CLIVE PLANNING & ZONING COMMISSION

RE: Site Plan - Ivory Lotus Therapy - 16360 Sheridan Ave

Re: 16360 SHERIDAN AVE - Ivory Lotus Mental Health - Site Plan

Ivory Lotus Commercial Site Plan 16360 Sheridan Avenue Clive, Iowa

IVORY LOTUS COMMERCIAL SITE PLAN
 GRADING PLAN PLAN

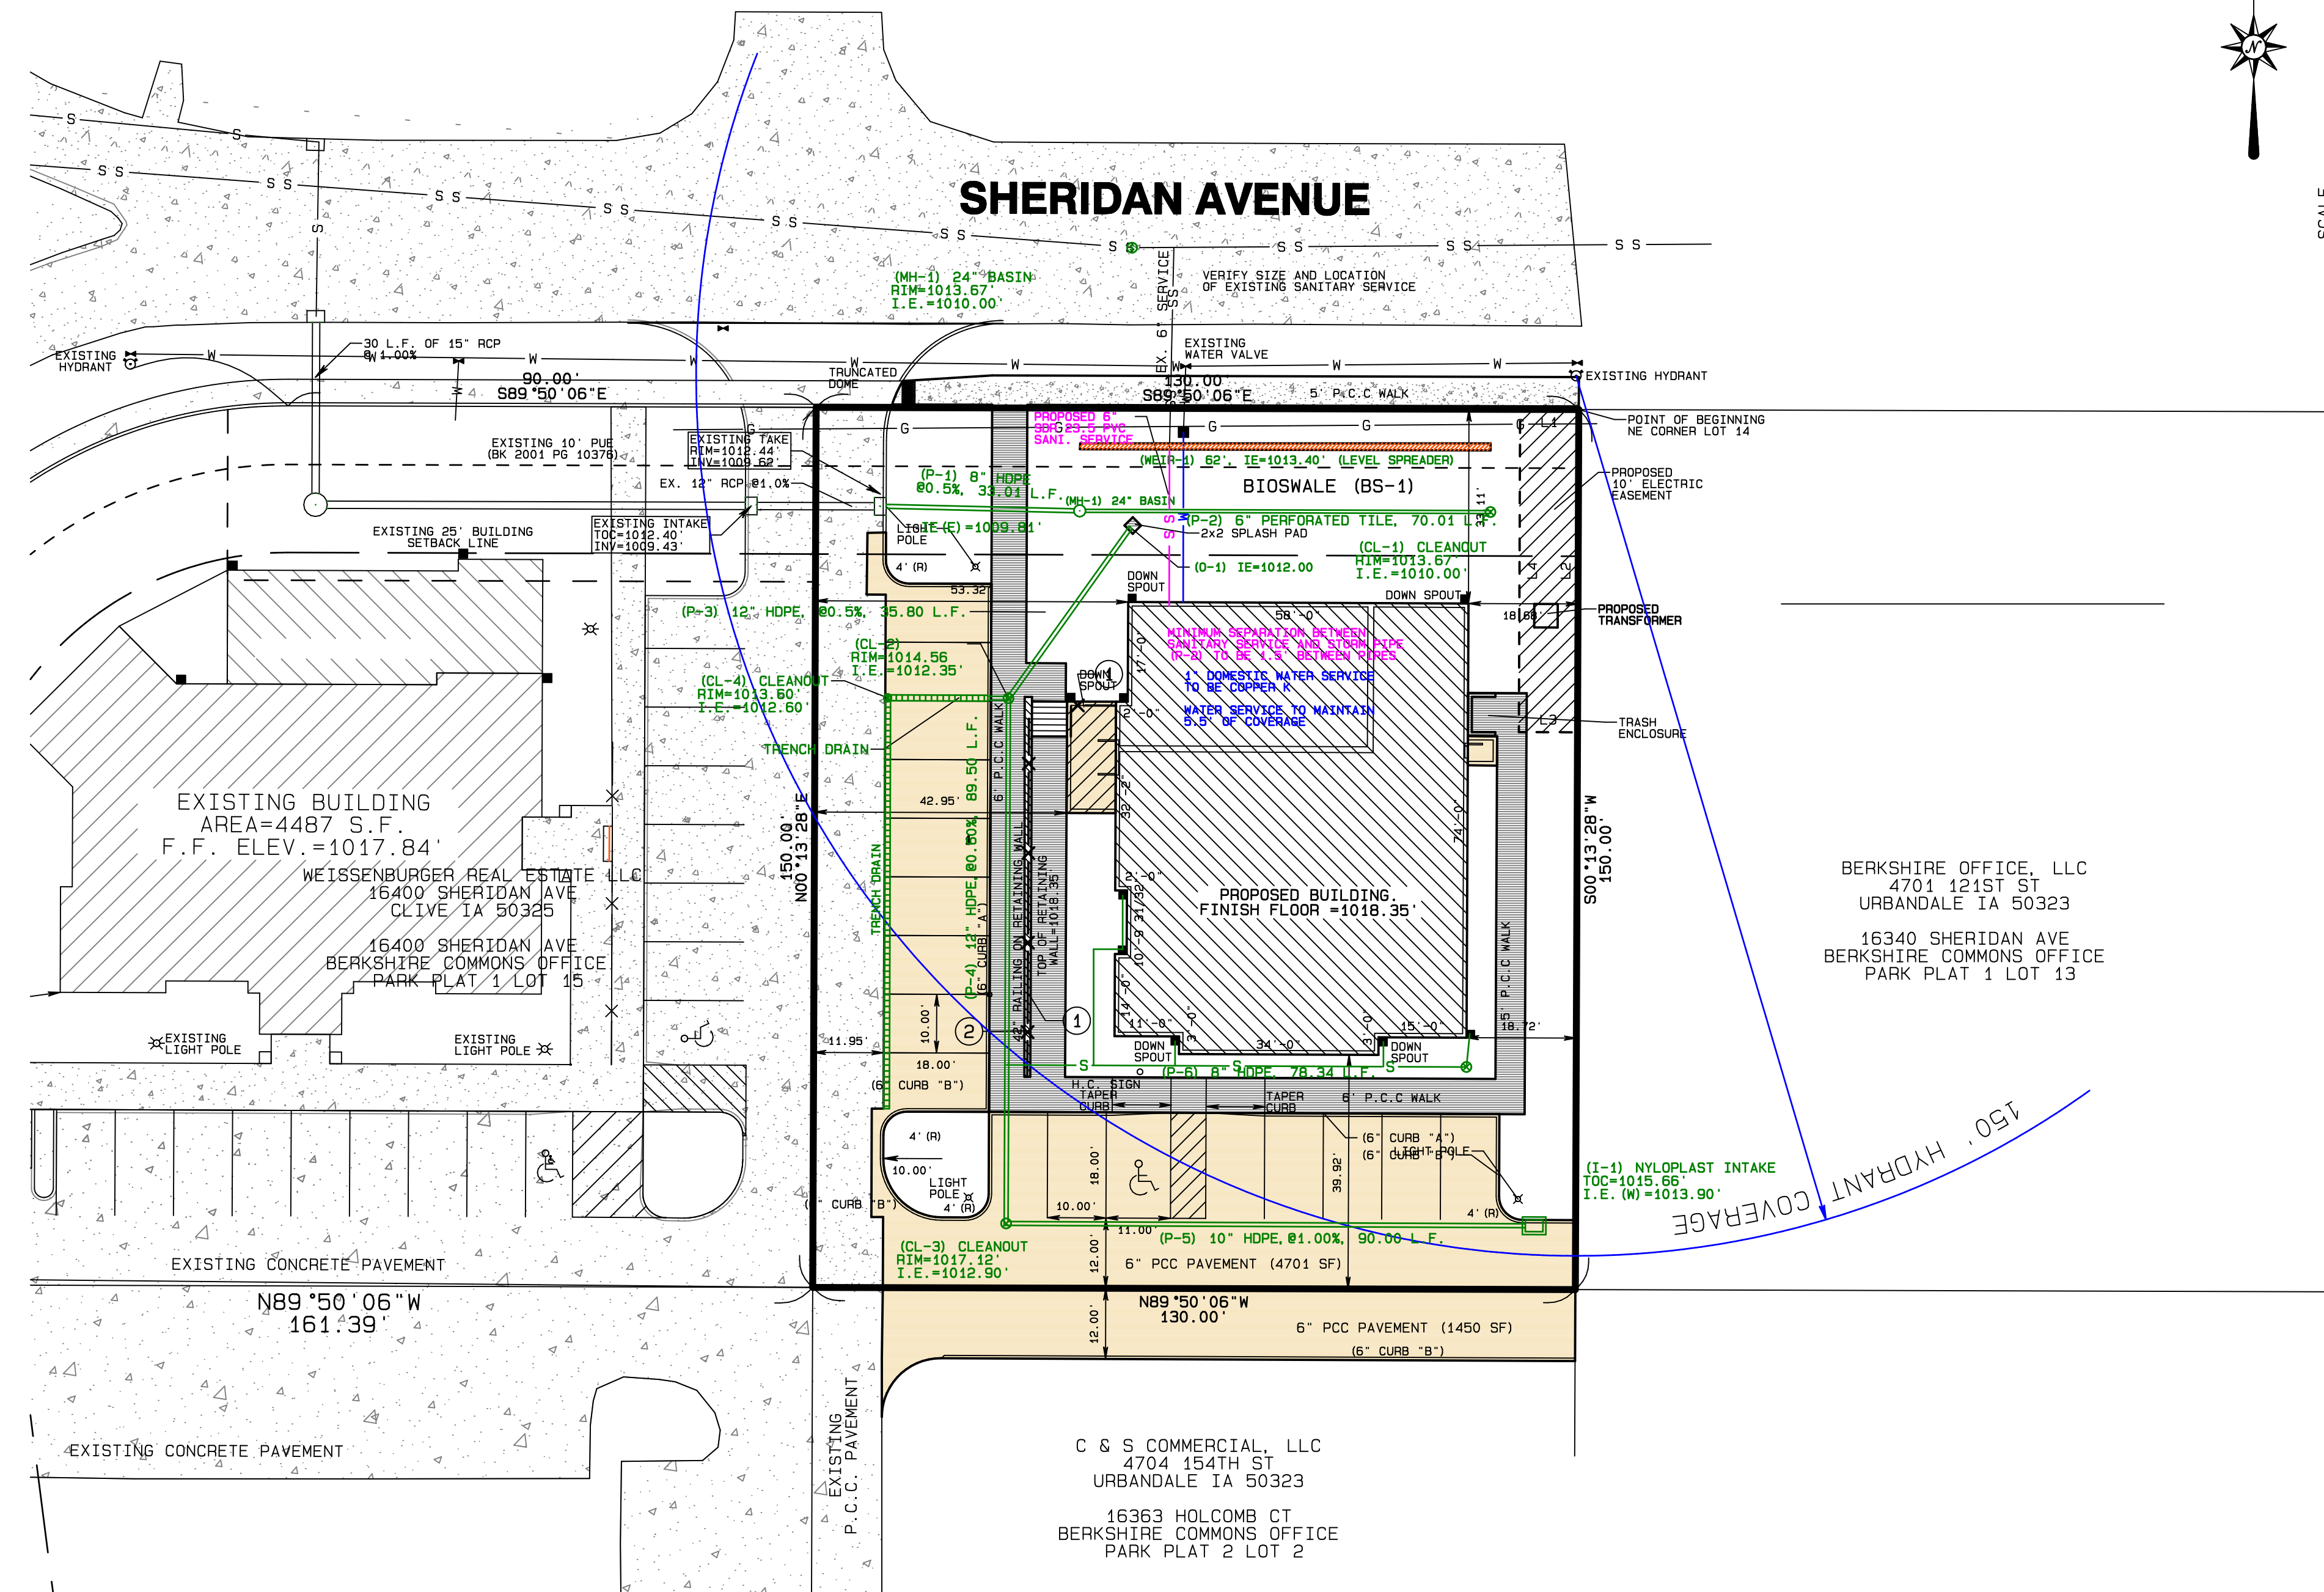
1. Please update the note indicating 2.5' of exposed foundation wall on the grading page. The Architectural Submission shows 2 feet of stone veneer being installed from the top of the exposed foundation to grade.

IVORY LOTUS COMMERCIAL SITE PLAN
 DIMENSIONING

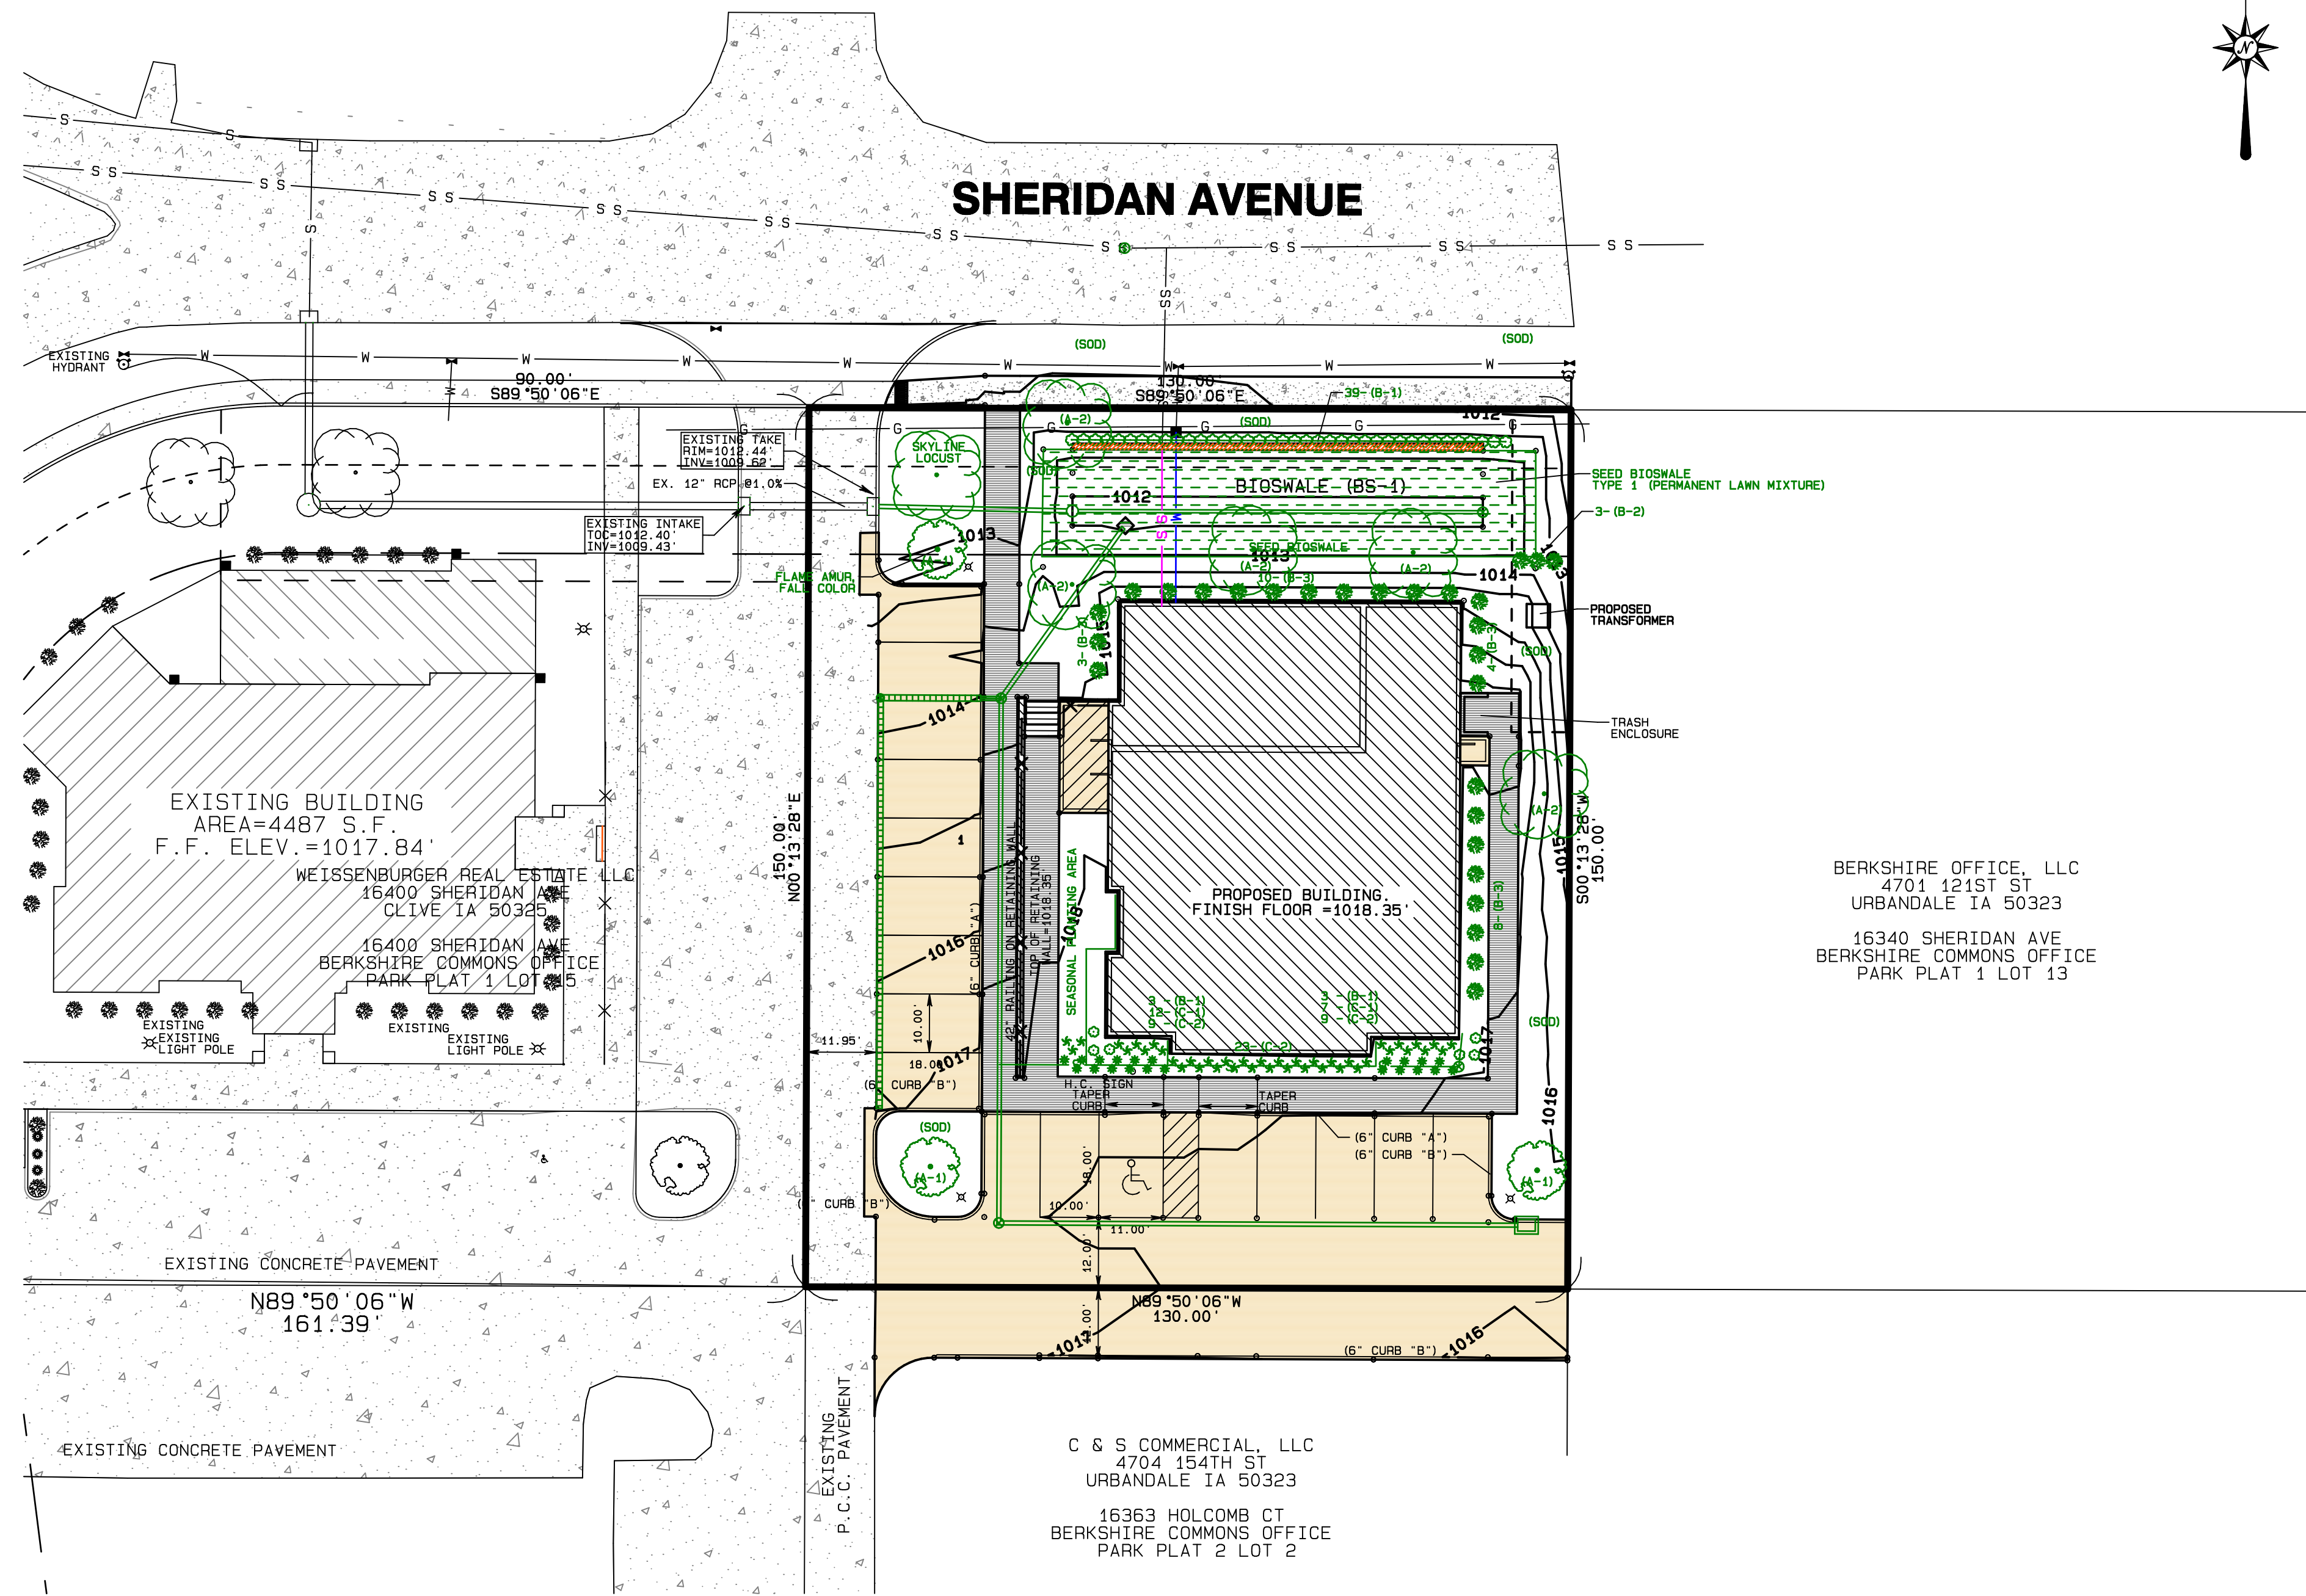
1. Staff understands geothermal well locations are still being determined. If the well locations are not able to be determined prior to Council consideration of the site plan, a site plan amendment may be required once additional information is provided.

2. Staff understands an ingress/egress and private storm sewer easement between the property and Lot 2 Berkshire Commons Office Park Plat 2 (16363 Holcomb Ct) is in process. A copy of the executed easement must be received prior to issuance of building permits.

3. Staff recommends documenting the ingress/egress easement between the property and Lot 15 Berkshire Commons Office Park Plat 2 (16400 Sheridan Ave) in a standalone easement document. The covenants establish the requirement for each lot to provide ingress/egress within the development; however, clarifying the maintenance obligations while the pavement is still in good condition may prevent future concerns. Staff recommends reaching out to Denise Richardson, Operations Manager at Weissenburger Investments, at denise.a.richardson@lpl.com.
